# Nant Llesg Surface Mine

## **Second Addendum to Environmental Statement**

**Second Addendum to the Environment Statement**

**Figure ESA13.1**  
**Typical Appearance of Acoustic Fence**

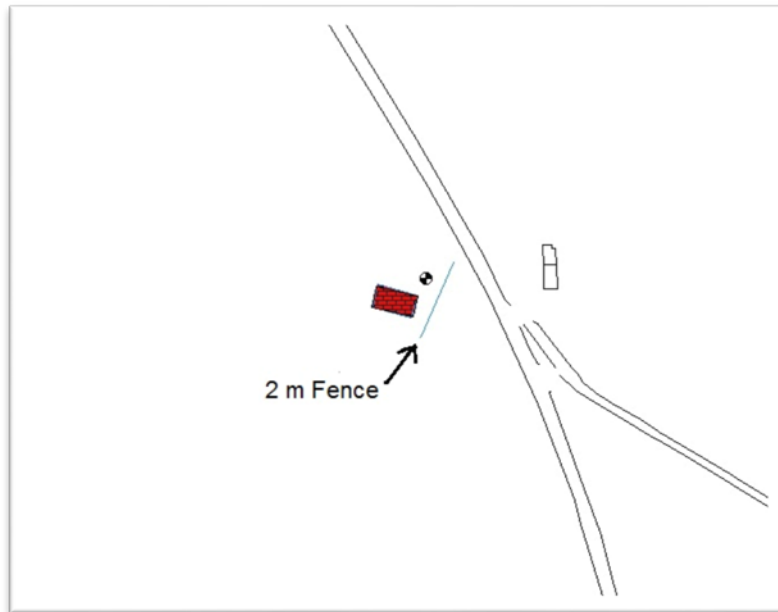
- 13.15 The 2 m high acoustic fence would conform to BS EN 1793–2 (category B3). It would be of timber construction with 34 mm 'tongue and groove' horizontal boarding set between timber posts. Typical construction detail of the acoustic fence is shown on Drawing MA/NL/PA/058 and illustrated in Figures ESA13.1 and ESA13.2 below.
